CITY PLANNING COMMISSION

APPLICATION: A. Negative Declaration
B. Rezone 5.45+ vacant acres from Single Family Alternative (R-1A) to Multi-Family (R-2B) zone.

PROPOSAL: The applicant is requesting the necessary entitlements to construct 20 duplexes and 56 apartment units.

APPLC. NO. P88-371 MEETING DATE January 26, 1989 ITEM NO. 13

EXHIBIT A
SITE PLAN

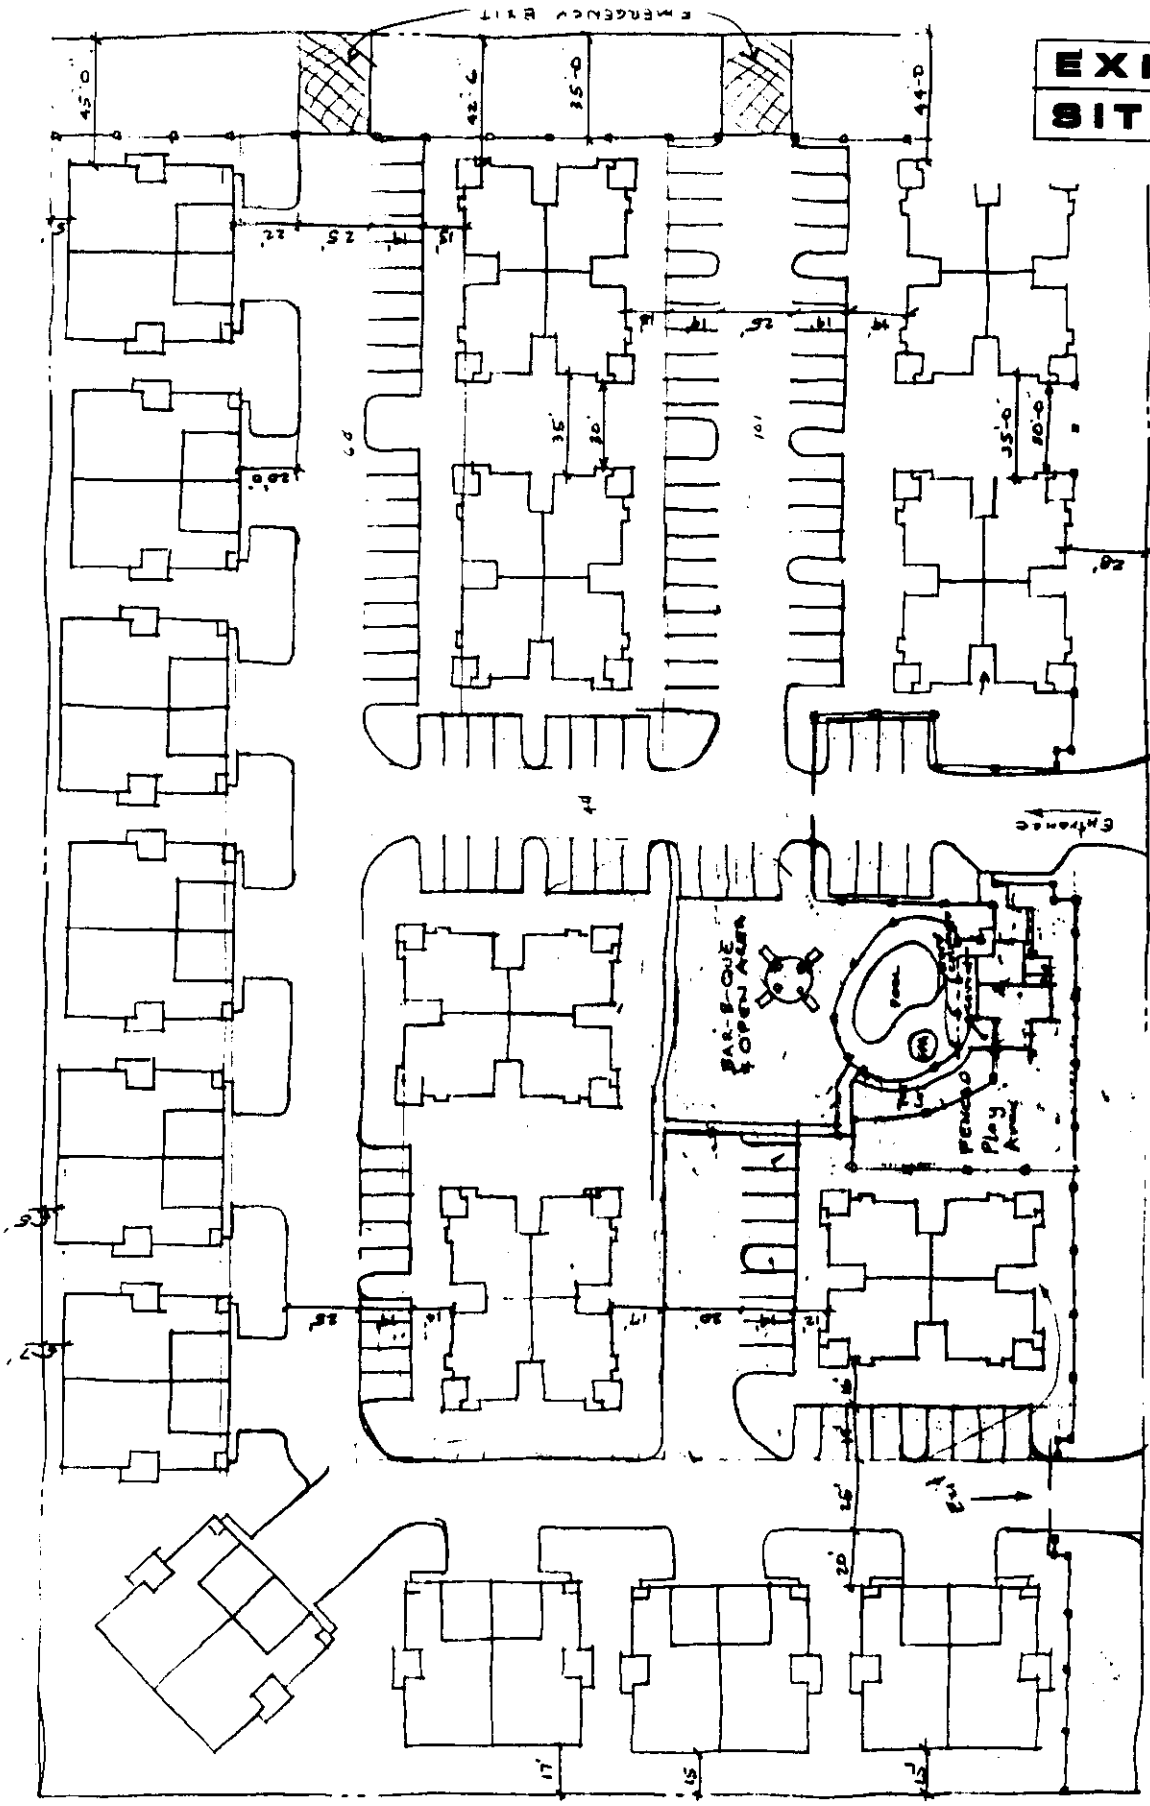
The submitted site plan indicates the proposed duplexes on the north and west perimeter of the subject site and apartments on the interior and south perimeter (see site plan). The recreation building and open outdoor area fronts on Bell Avenue. The site plan shows a fence along Bell and Norwood Avenue. The applicant indicated to staff that the fence will be made of wrought iron material with a security gate fronting on Bell Avenue and two emergency exits fronting on Norwood Avenue. A six foot, wooden fence exist along the north and west property lines separating single family residences from the subject site. Staff recommends that a six foot high, wrought iron fence be placed along the east and south property lines.

Currently, there are no trash enclosure locations indicated on the site plan. Staff recommends that at least three trash enclosure locations be identified on a revised site plan to be reviewed and approved by the Planning Director. Trash enclosures shall comply with Zoning Ordinance requirements.

The applicant is also discouraging parking on the street by installing a security fence on the interior property line and providing eight spaces outside of the enclosed gate. Staff recommends that the projects parking area comply with the 50 percent shading of surfaced areas required by the Zoning Ordinance.

No landscaping and irrigation plans were submitted for staff review and approval. Staff recommends that a minimum 25 foot landscape setback be provided along Norwood Avenue and Bell Avenue. The landscape setback shall consist of lawn material with three and one-half foot undulating berms and trees along Norwood and Bell Avenue. No landscaping is indicated on the site plan along the perimeter or within the project area.

- a. Provide three foot flairs on driveways.
- b. Remove bubble shape from west driveway on Bell Avenue.
- c. Construct Norwood Avenue to an 80 foot right-of-way.
- d. Construct Bell Avenue to a modified 80 foot right-of-way.
- e. Provide an expanded intersection at Bell Avenue and Norwood Avenue to the satisfaction of the Traffic Engineer.

1. The applicant shall redesign the site plan to the satisfaction of the Planning Director prior to issuance of building permits. The revisions shall include increasing the width of the back out maneuvering space to 26 feet and indicating the three trash enclosure locations.
2. A six foot high wrought iron fence shall be placed along the east and south property lines.

11. The parking lot shall comply with the 50 percent shading of surfaced areas required by the Zoning Ordinance.
12. A minimum 25 foot landscape setback shall be provided along Norwood Avenue and Bell Avenue. The landscape setback shall consist of lawn material and shrubs with three and one-half foot undulating berm and trees along Norwood Avenue and Bell Avenue.

14. All new signage shall comply with the Sign Ordinance regulations.
15. Provide three foot flairs on all driveways.
16. Remove bubble shape from far west driveway on Bell Avenue.

17. Construct Norwood Avenue to an 80 foot right-of-way and construct Bell Avenue to a modified 80 foot right-of-way.

18. Provide an expanded intersection at Bell Avenue and Norwood Avenue to the satisfaction of the Traffic engineer.
19. Living units with windows within 120 feet of the east property line and within 80 feet of the south property line must be equipped with ventilation or air conditioning systems which will provide adequate indoor air quality while the windows are maintained closed.
20. The maximum amount of sound attenuation required between the exterior and interior of the buildings is 22dBA. This amount of sound attenuation is attainable with standard glazing and siding. Windows with a direct or side view of Norwood Avenue, in the three buildings directly adjacent to this roadway, should be equipped with weather seals incorporating an air tight membrane.

Duplex Elevations

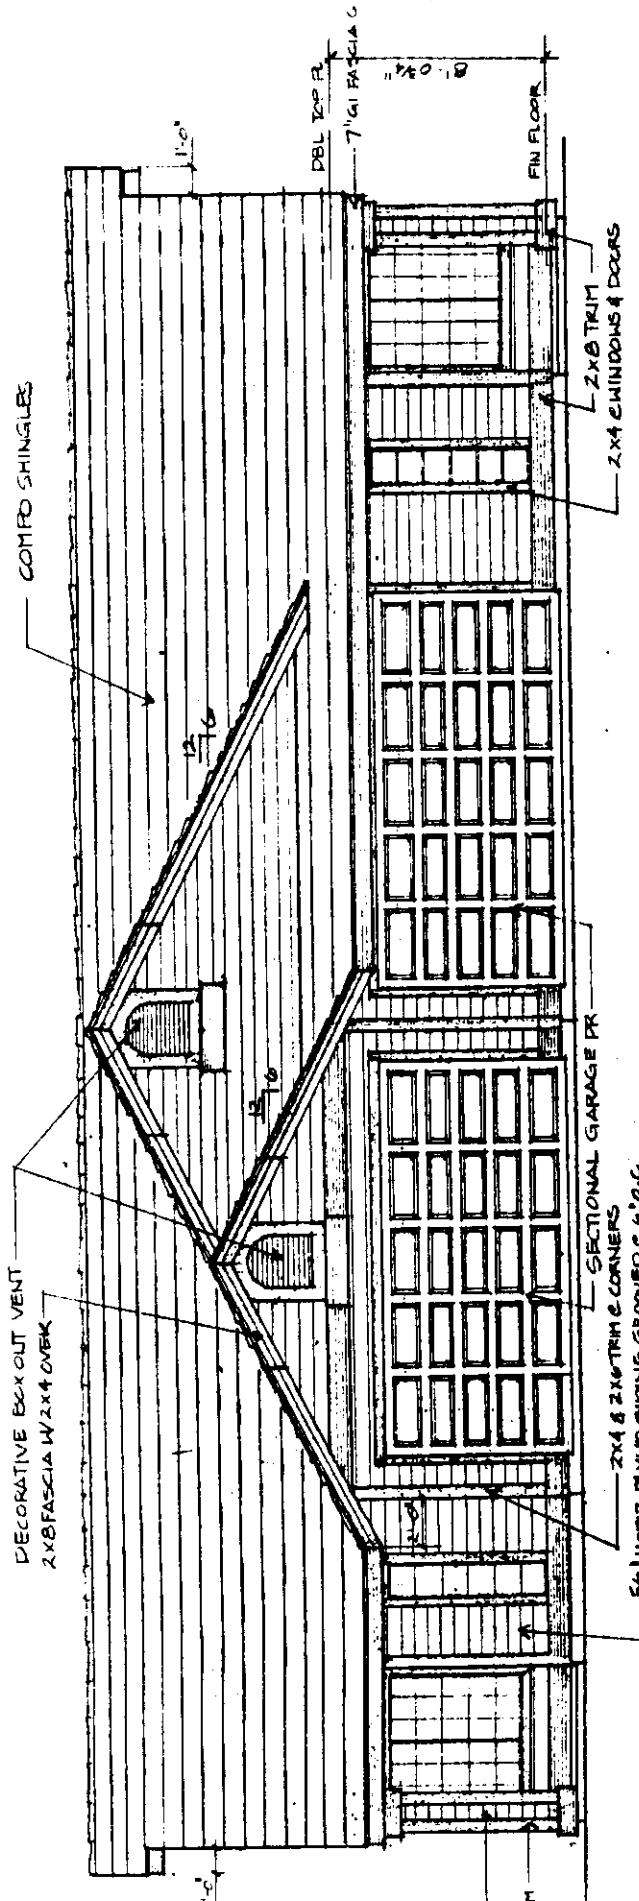
The building elevations for the development feature the use of horizontal plywood siding walls with grey and blue trim color. The roof material is made of composition shingles. Three bedrooms are proposed for the duplexes and two bedrooms are proposed for the apartment units. Planning staff and design review staff reviewed the proposed apartment, duplex and recreation structures and propose the following modifications:

1. Roofing materials shall be a 30 year architectural grade subject to Planning Director approval.
2. Exterior building material shall be made of horizontal wood siding or horizontal masonite siding. The masonite shall be a heavy thickness on all buildings.

3. The applicant shall provide six foot high wood fencing material between the duplexes to allow for privacy.
4. Building materials and coloring shall be reviewed and approved by the Planning Director. Each building shall have a body color and trim color and shall be two distinct colors.

3. The trash enclosures shall meet City Zoning Ordinance requirements.
4. Roofing materials shall be a 30 year architectural grade subject to Planning Director approval.

5. Exterior building material shall be made of horizontal wood siding or horizontal masonite siding. The masonite shall be a heavy thickness on all buildings.

6. The applicant shall provide six foot high wood fencing material between the duplexes to allow for privacy.
7. Building materials and coloring shall be reviewed and approved by the Planning Director. Each building shall have a body color and trim color and shall be two distinct colors.

Apartment/Elevations

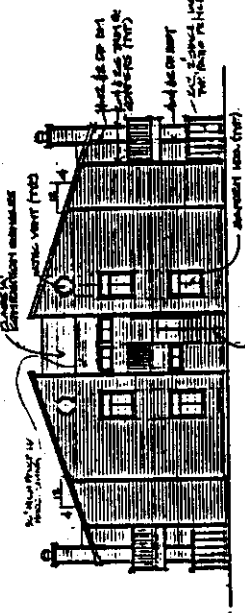
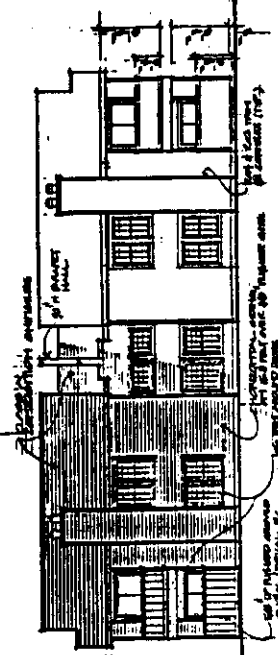
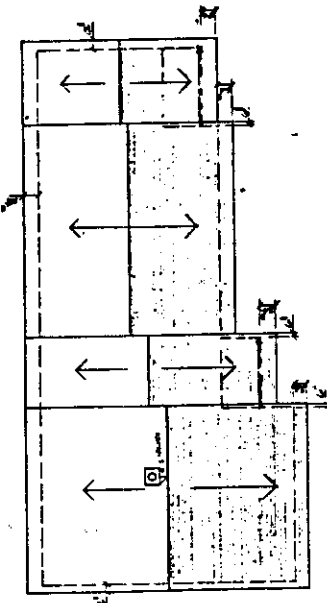
6. Patio fences and balcony railings shall be solid for privacy and to screen material stored on the interior from public view.
7. The proposed parapet wall on the apartment buildings shall be covered in a material to match all other exterior walls of the structure.

9. Patio fences and balcony railings shall be solid for privacy and to screen material stored on the interior from public view.
10. The proposed parapet wall on the apartment buildings shall be covered in a material to match all other exterior walls of the structure.
